Product Change Notification (PCN)

Product group:	SEMİKRON legacy products	Rev.:	0
No.:	PN24-114	Change of material numbers, new data formats and harmonization of product marking due to introduction of a new ERP system	15.11.2024

Subject of change: Product related changes due to change of the ERP system

Example of new product marking:

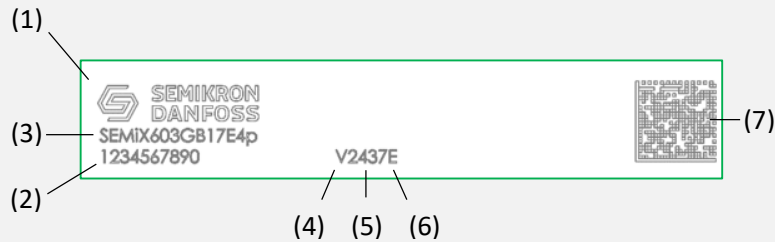
- Currently, different product markings are used for different product types.
- With the change of the company name and changes triggered by the new ERP system, a harmonization of the product marking will take place for the product lines addressed by this PCN.

- The labels of all affected products will contain following information:
 - (1) company name (updated to Semikron Danfoss)
 - (2) batch number
 - (3) product name

- (4) production site identifier (updated/new for some factories)
 - (5) date code
 - (6) product status in case of non-serial product
 - (7) DMX code
- Following contents will be removed from the product label

- (8) product line name
 - (9) circuit
 - (10) UL recognized mark
 - (11) part number (further available in DMX)
 - (12) serial number for traceability within a batch (further available in DMX)

- (13) character 'R' behind the date code (indicating RoHS conformity)

Example of current product marking (marked content will be removed):

- Exemptions from this rule apply for parts with already limited marking content (discrete parts and some power bridges)
- Extensions to the general content of the product marking are possible (e.g. marking of V_{CE} classification)
- For more details, supporting documentation will be available in CW51/2024
